UNITED STATES PATENT AND TRADEMARK OFFICE

APPLICATION NO.	FILING DATE	FIRST NAMED INVENTOR	ATTORNEY DOCKET NO.	CONFIRMATION NO.
10/055,582	01/23/2002	Dennis P. Silver	11899	7015

Office Action Summary	Application No. 10/055,582	Applicant(s) SILVER, DENNIS P. 	
	Examiner Árpád Fábián Kovács	Art Unit 3671

DETAILED ACTION

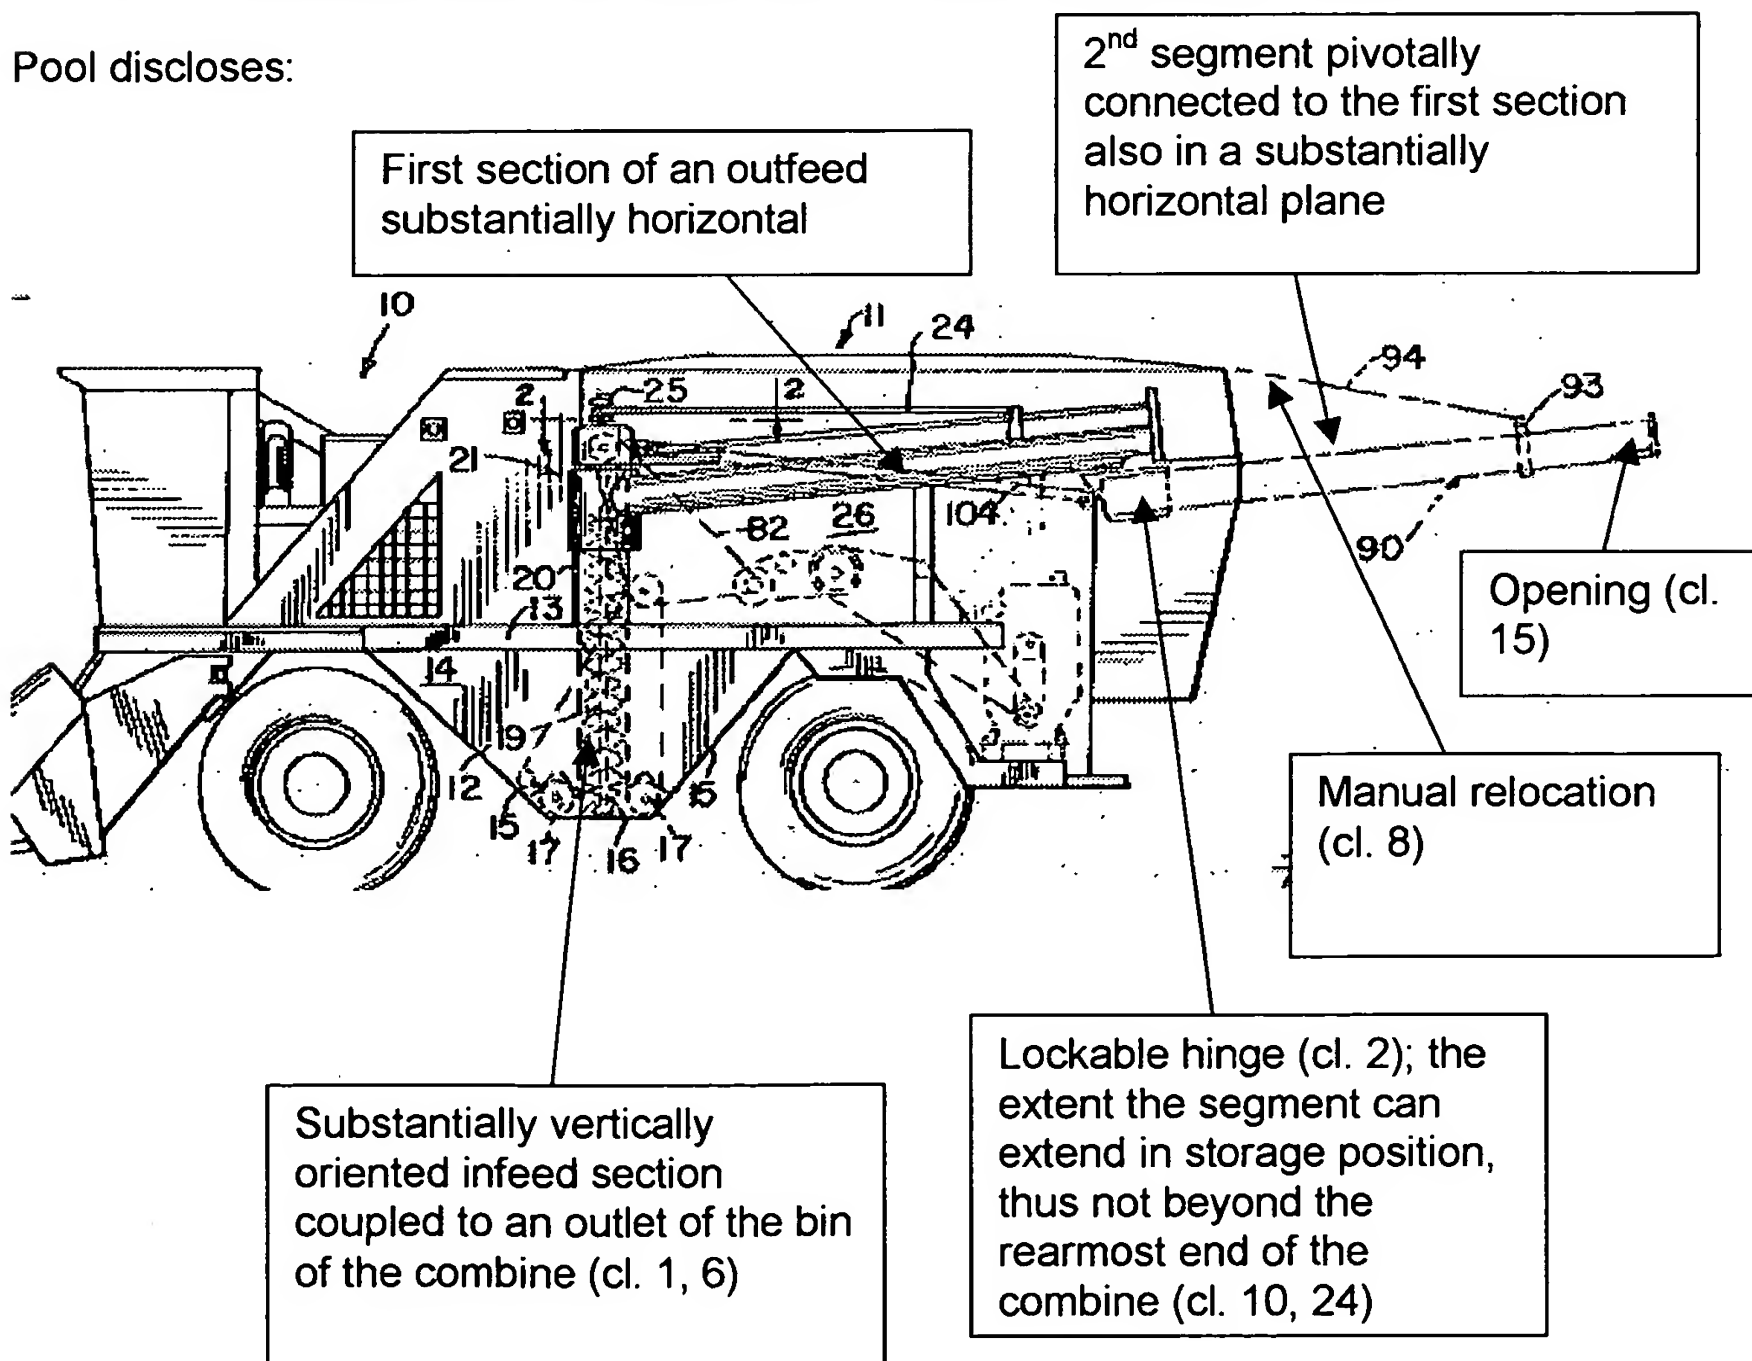
2. Claims 1-2, 4-6, 8, 10-11, 13, 15-18, 22-40 are rejected under 35 U.S.C. 103(a) as being unpatentable over Pool (3825138), in view of Barinov (SU 1724126 A1).

Pool discloses:

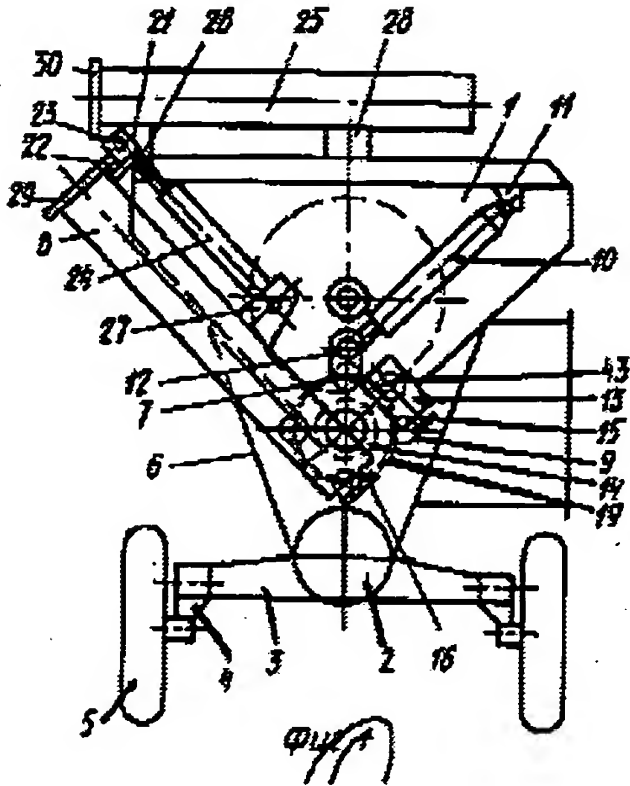
In re claims 4, 17-18, in storage position the flyers do not operate thus it is prevented to accidentally release through the open end any grain;

In re claims 5, 13, 23, 26-27, 31, in storage position both segments are parallel to the longitudinal axis of the combine;

Pool does not disclose a coaxial pivoted hinge connection between the first & the second segments.

Barinov as shown below and disclosed in the abstract hingedly & pivotally connecting a second segment for giving wider range of use of the discharge auger system.
